UNC Charlotte Phase 16

Addendum #4

Revision Narrative

2021-09-08

E-200S

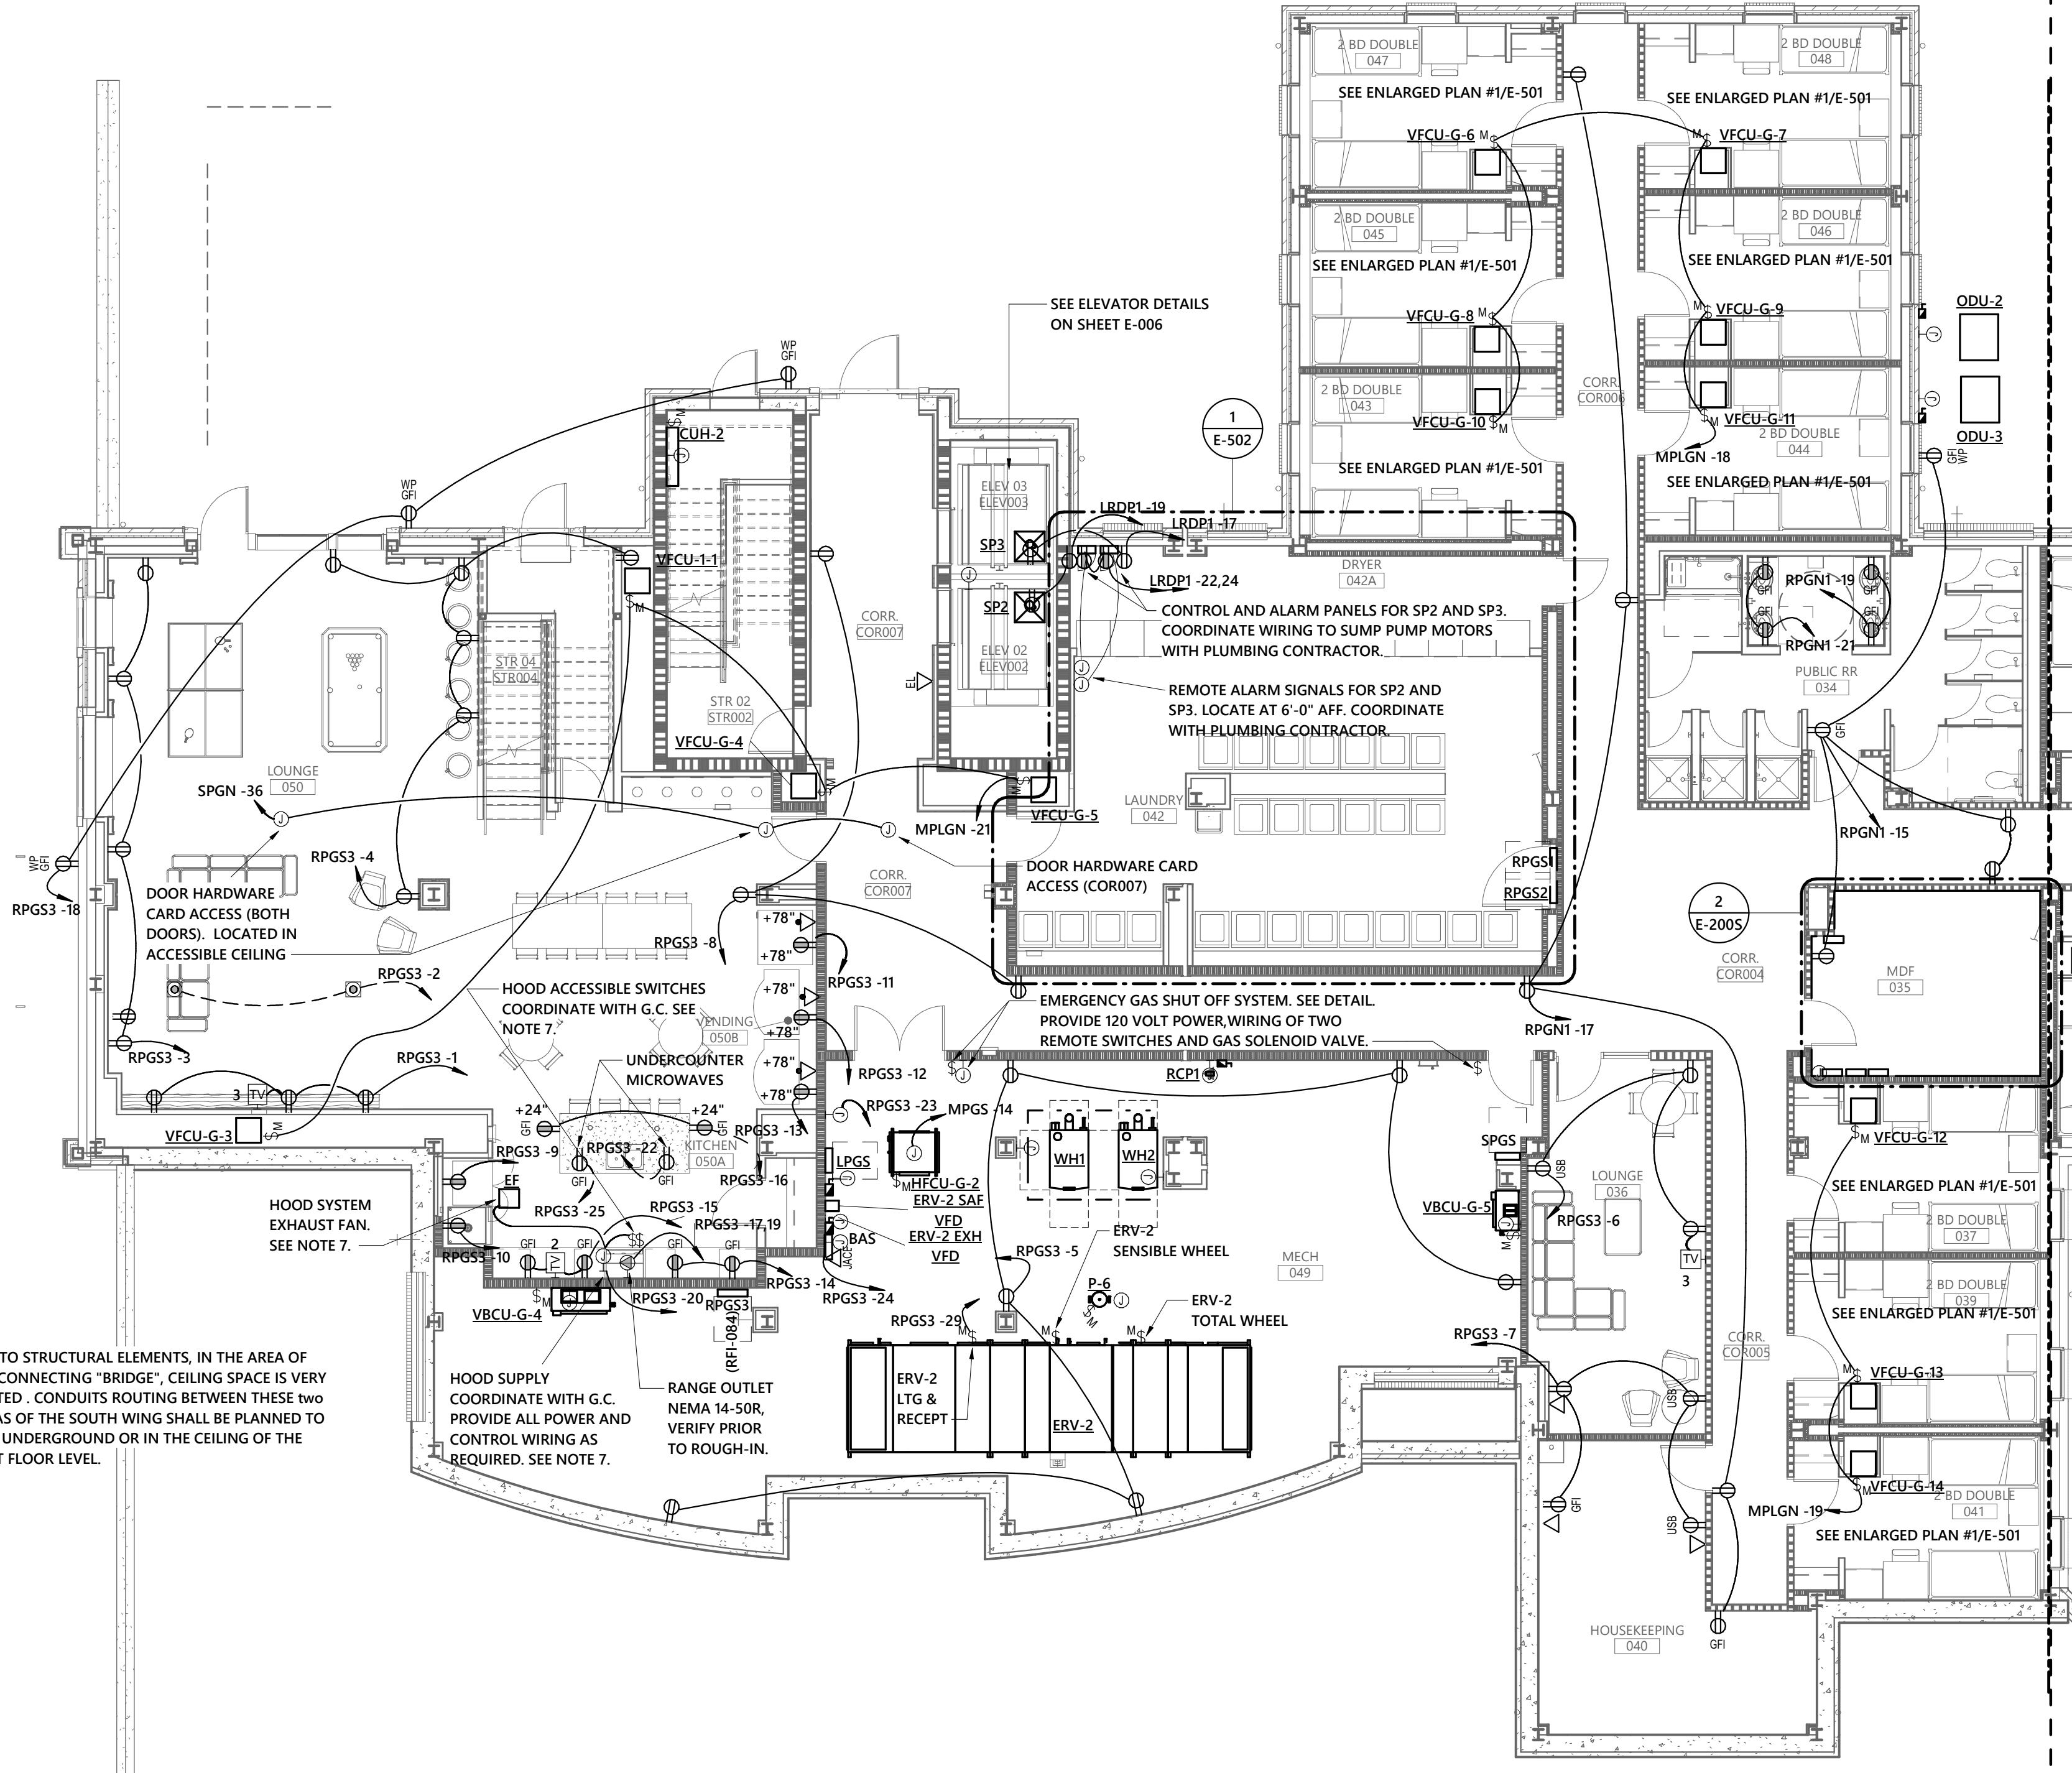
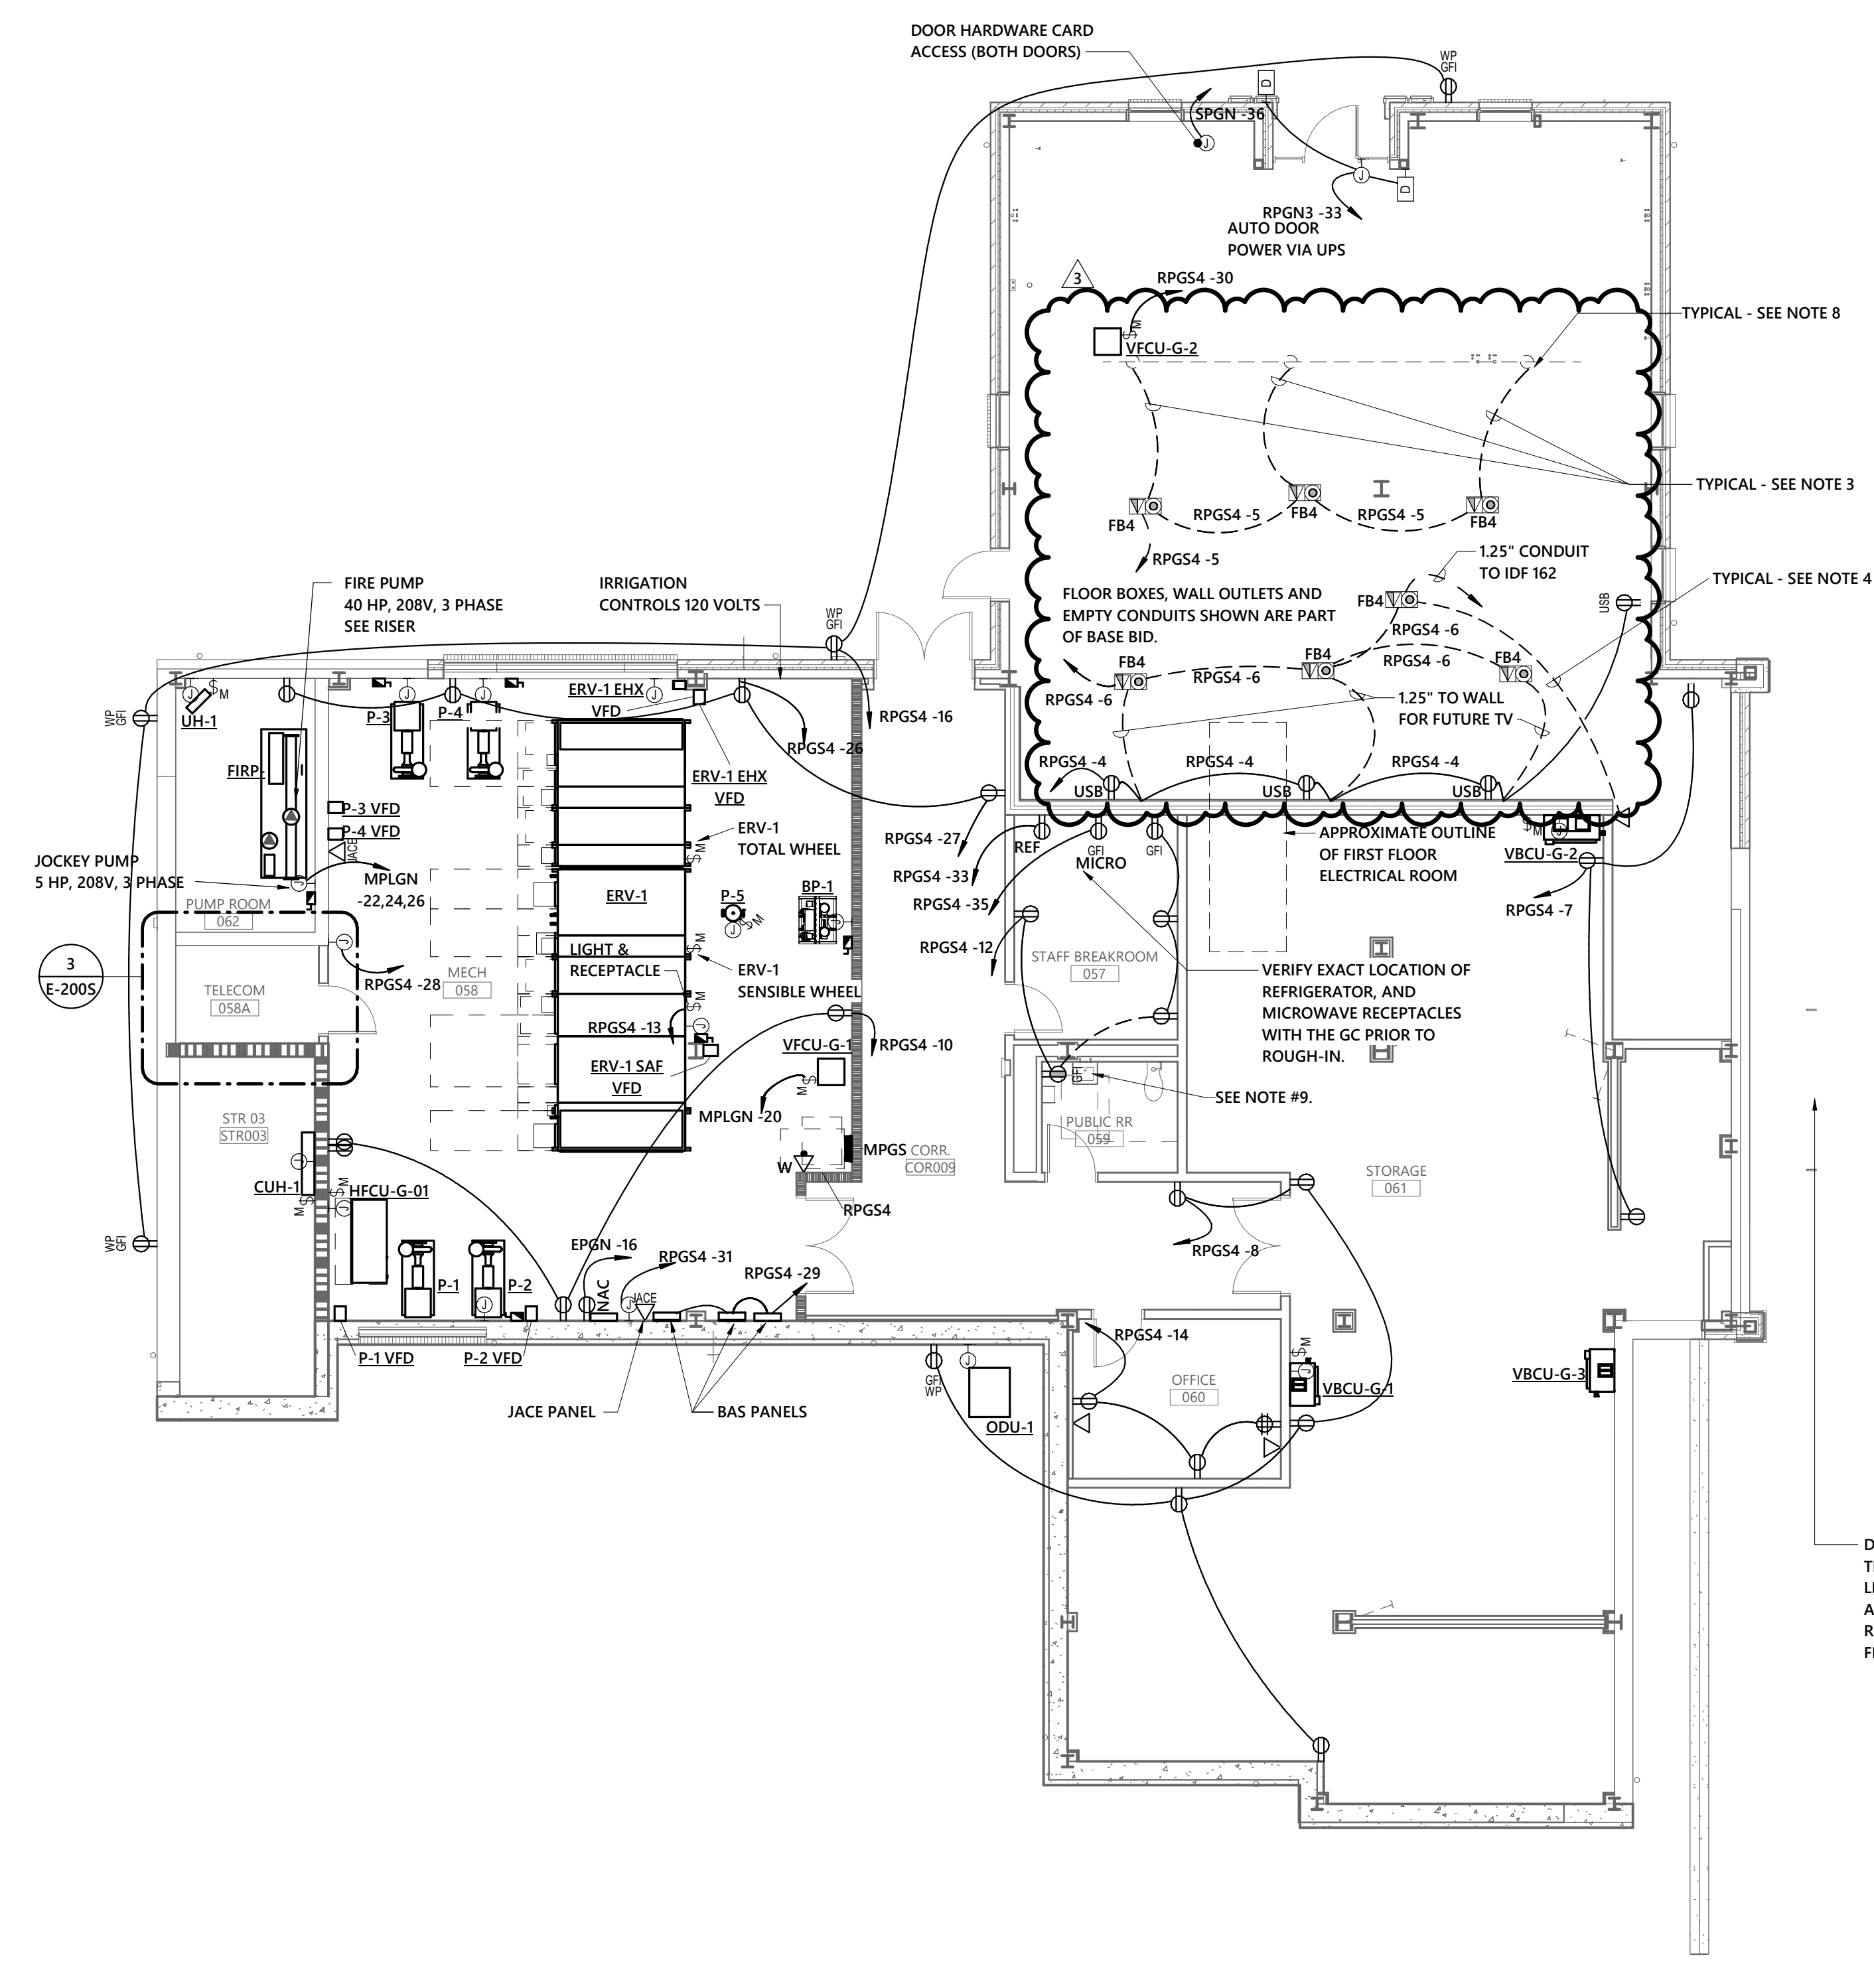
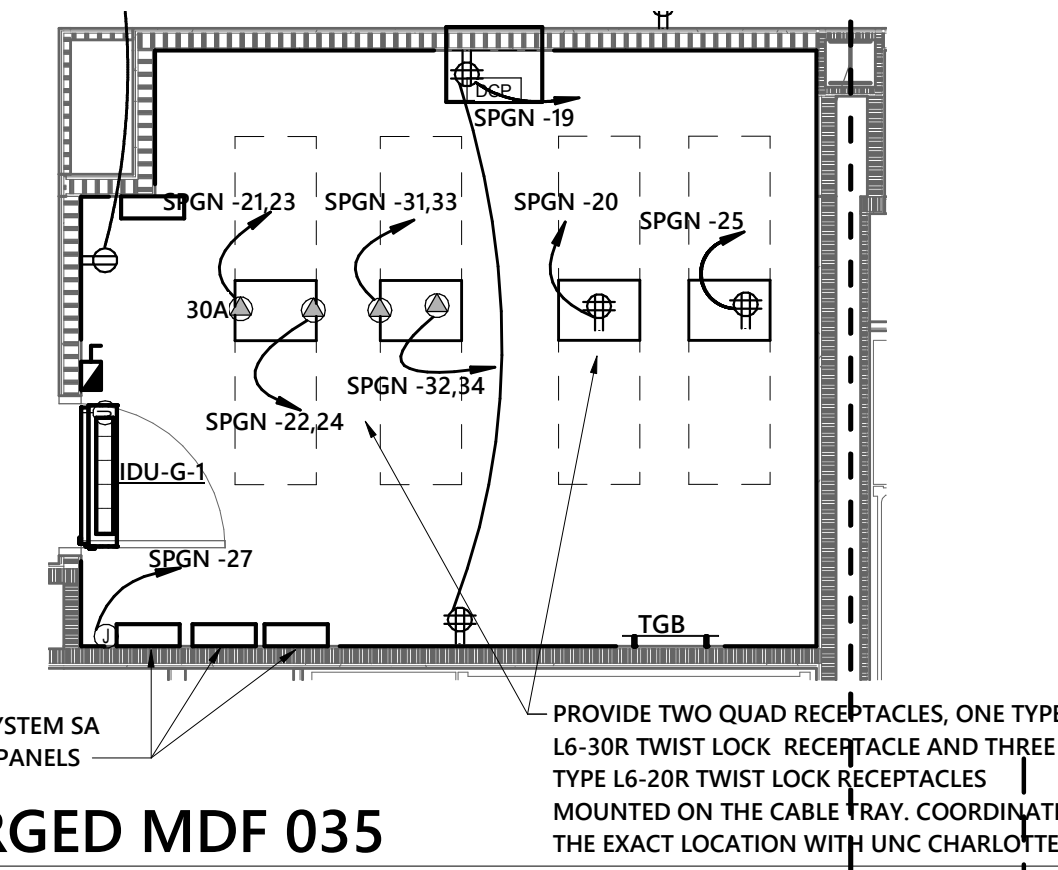
E-200S - Removed conduit, conduit notes updated.
